## COUNCIL ASSESSMENT REPORT

<b>Panel Reference</b>	PPSSNH-155
<b>DA Number</b>	DA2020/1167
<b>LGA</b>	Northern Beaches Council
<b>Proposed Development</b>	Demolition works and construction of a mixed use development to accommodate a cafe, church, conference centre, boarding house and two level basement car park
<b>Street Address</b>	Part Lot 28 DP 7413, 9 Francis Street and 28 Fisher Road, Dee Why
<b>Applicant/Owner</b>	Baptist Churches of NSW Property Trust (Owner) The George Group Pty Ltd (Applicant)
<b>Date of DA lodgement</b>	22 September 2020
<b>Number of Submissions</b>	38 submissions which includes: <ul style="list-style-type: none"> <li>• 16 submissions in support;</li> <li>• 22 submissions in opposition</li> </ul>
<b>Recommendation</b>	Refusal
<b>Regional Development Criteria (Schedule 7 of the SEPP (State and Regional Development) 2011)</b>	Development with a Capital Investment Value (CIV) of more than \$5 million for affordable housing (which includes a Boarding House)

<b>Report prepared by</b>	Lashta Haidari – Principal Planner
<b>Report date</b>	27 January 2021

Figure 7 North Elevation (Source: The Georges Group Pty Ltd)

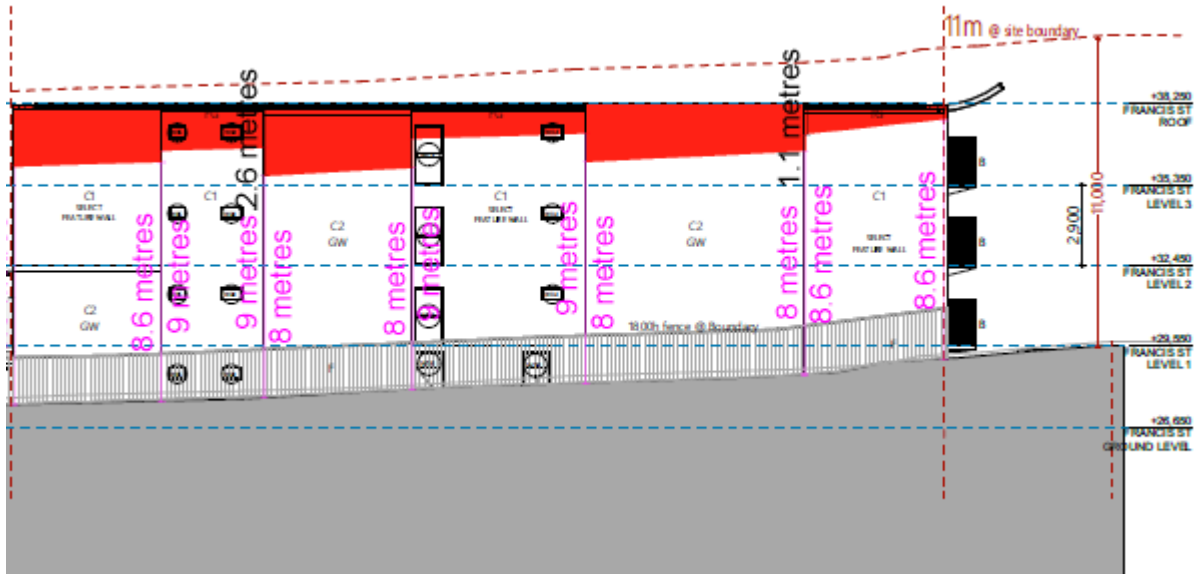
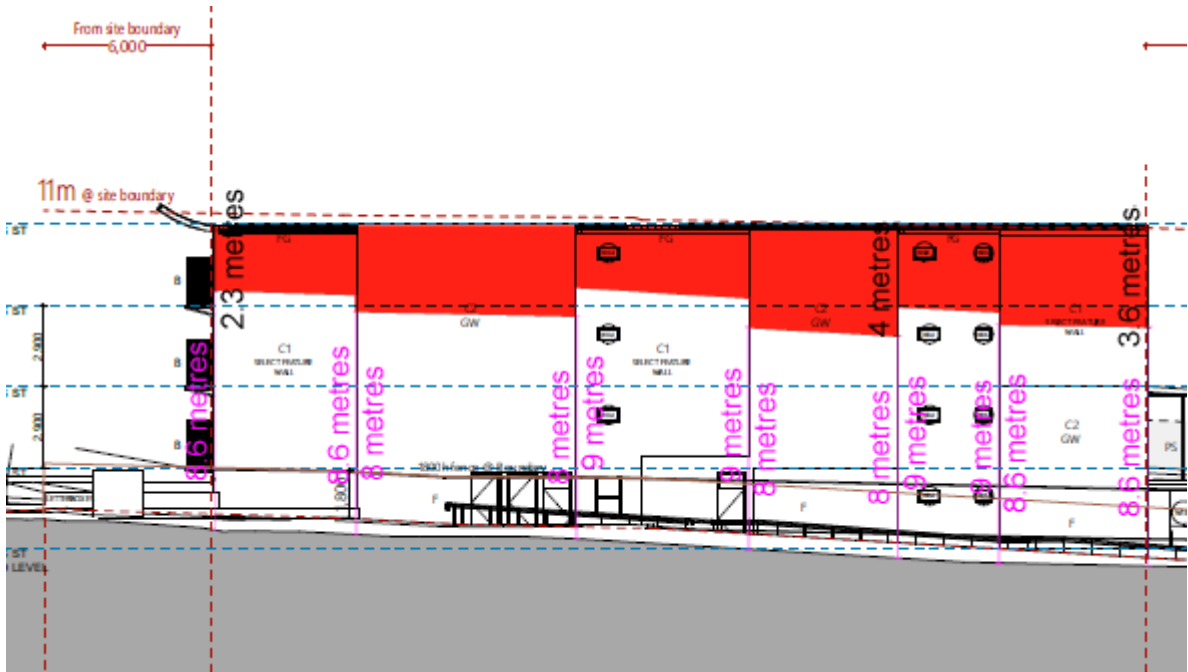
The variation extends for the length of the western building as depicted in the following figures:

The development fails to provide any increased separation as the building envelope has increased. While this would not provide any additional relief at ground level, it will certainly provide a greater sense of openness and separation from the adjoining properties.
